HYDROLOGY H15/D35 MOTOROLA SERVICE CENTER AND MINI WAREHOUSE

RESUBMITTAL--10/9/85

DRAINAGE / GRADING PLAN
MOTOROLA BUILDING

SHEET 1 OF 1

1 PLAN

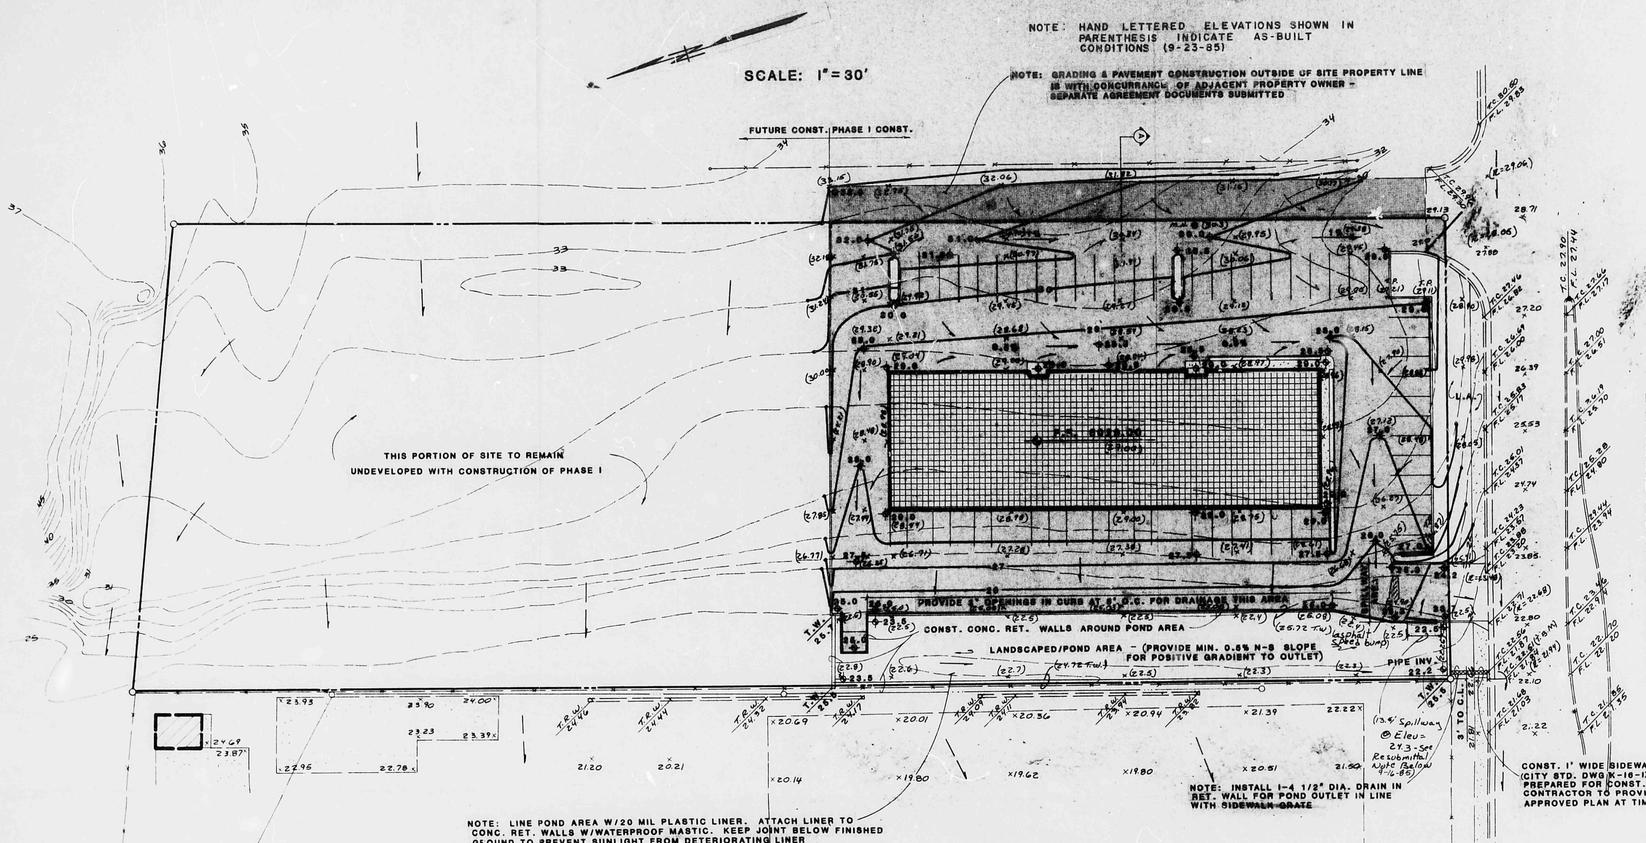
Plan resubmitted to show three variations from approved plan.

1. West wall of pond constructed to elevation 24.72' instead of 25.5'.
2. Speed bump constructed across west drive, precluding original spillway outlet from pond.
3. Pond rectangular spillway actually constructed to following dimensions and elevations: width = 3.3', depth = 0.7', elevation at flow line = 24.0'

Volume of pond at spillway flow line (24.0') is 11,340 ft³ ((24.0 - 22.5)(7560)). Future developed volume of drainage to pond will be somewhat more than 13,500 ft³, only about 9800 ft³ of which must be ponded during controlled release at 1.3 cfs. Assuming both outlets (4.5" pipe and 3.3' spillway operating, the allowable release of 1.3 cfs occurs at pond elevation of $Q = 2.5(3.3)(0.7)^{1.5} = 4.6$ cfs; $Q = 0.6(\pi)(\frac{4.5}{12})^2\sqrt{64.4(0.7)} = 0.4$ cfs, At pond elevation = 24.12. Ponded volume = 11,025 ft³ (9800 ft³ = 11,250 ft³, which is more than the required amount of pond ft³.

If a 4.5" pipe is plugged, rectangular spillway has capacity of 5.4 cfs ($Q = 2.5(3.3)(0.7)^{1.5}$). Based on a flow routing analysis, this is more than three times the maximum outflow rate which would be encountered during a 100-year storm.

- INCREASED HEIGHT OF RETAINING WALLS AROUND POND AREA
- RELOCATED DRAINAGE SWALE WITHIN EAST PROPERTY LINE

REVISED 9-12-85: SECTION A ADDED
